## PLAT COMMITTEE

<b>Case Number:</b>	2024-PLT-013
<b>Property Address:</b>	3502 Watson Road ( <i>Approximate Address</i> )
<b>Location:</b>	Perry Township, Council District #8
<b>Petitioner:</b>	William R. Moldenhauer
<b>Zoning:</b>	D-3
<b>Request:</b>	Approval of a Subdivision Plat, to be known as Watson Hill, subdividing 1.13 acres into two lots.
<b>Waiver Requested:</b>	None
<b>Current Land Use:</b>	Single-Family Dwelling
<b>Staff Reviewer:</b>	Jeffrey York, Principal Planner

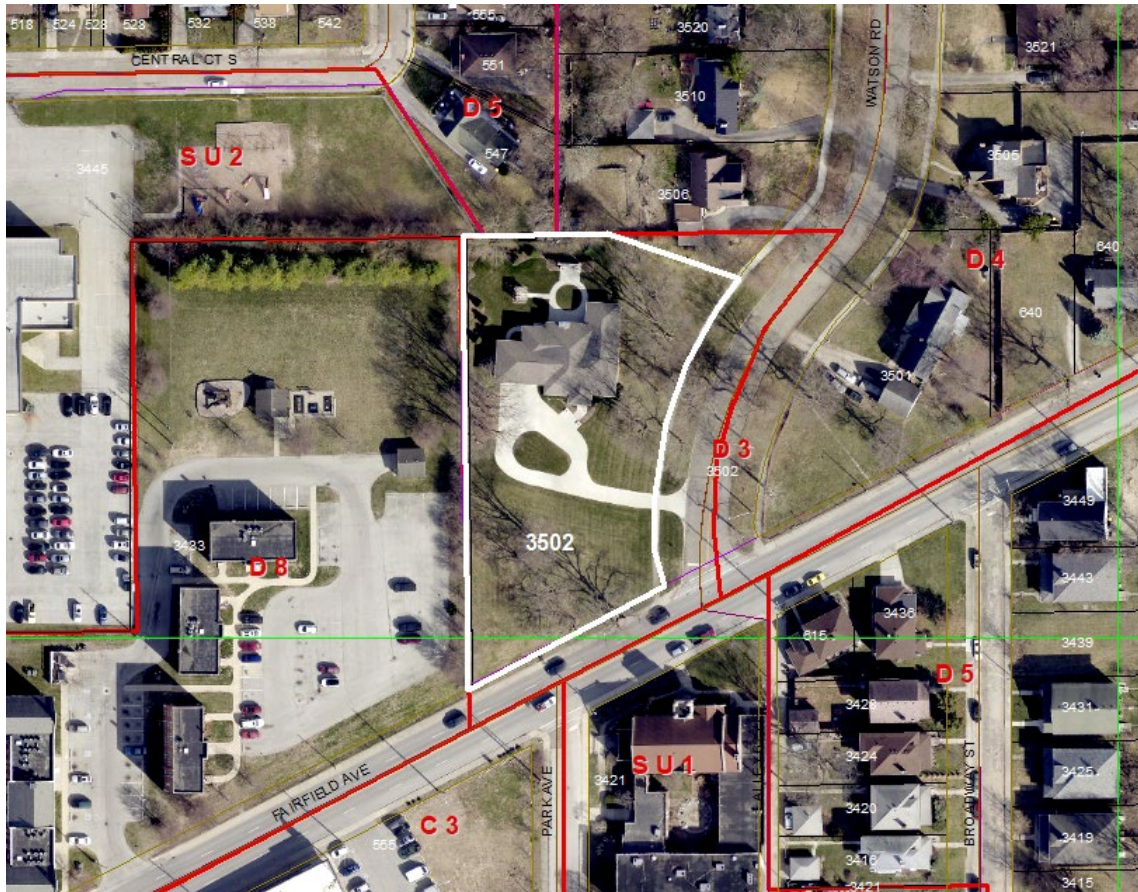
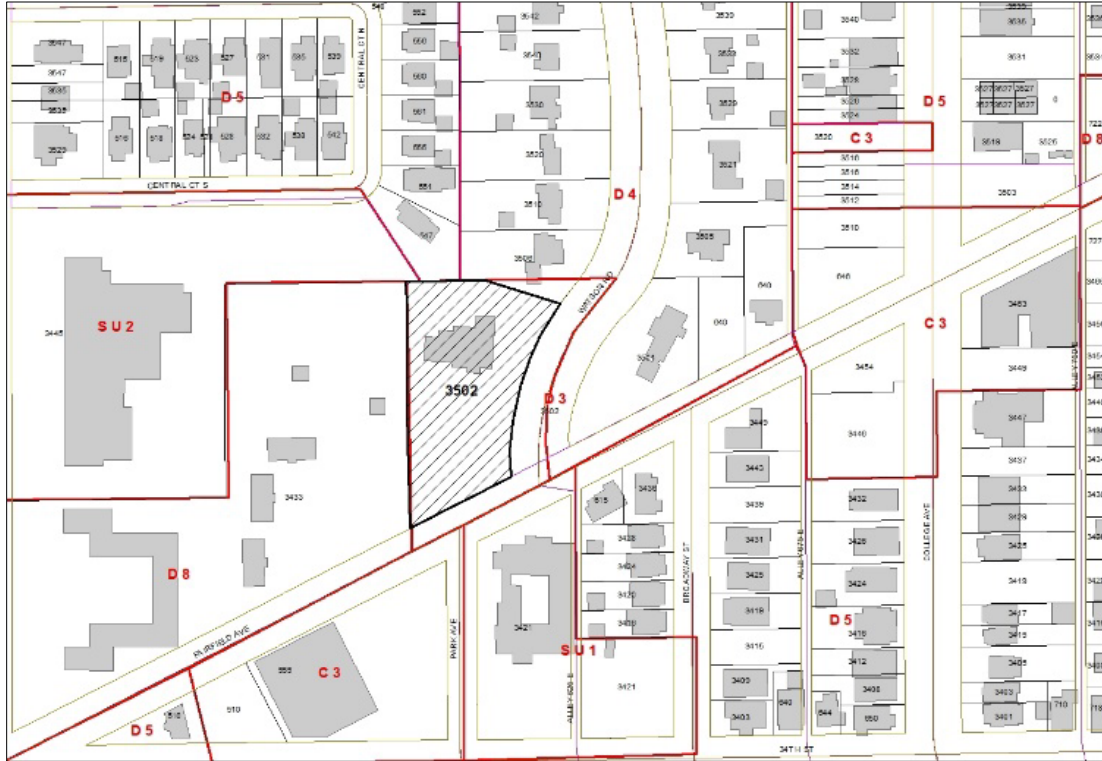
The petition indicates that the name of the plat would be Watson Hill, however, the plat identifies the plat name as Replat of Lot 88 and Watson Park. A condition has been added to the typical minor plat list of conditions that requests the name to match the name of the plat on the petition.

9. That the plat restrictions and covenants, done in accordance with the rezoning and / or variance commitments, be submitted prior to recording the final plat.
10. That all the standards related to secondary plat approval listed in Sections 741-207 and 741-208 of the Consolidated Zoning and Subdivision Ordinance be met prior to recording the final plat.
11. That the name of the plat be identified as Watson Hill on the final plat.
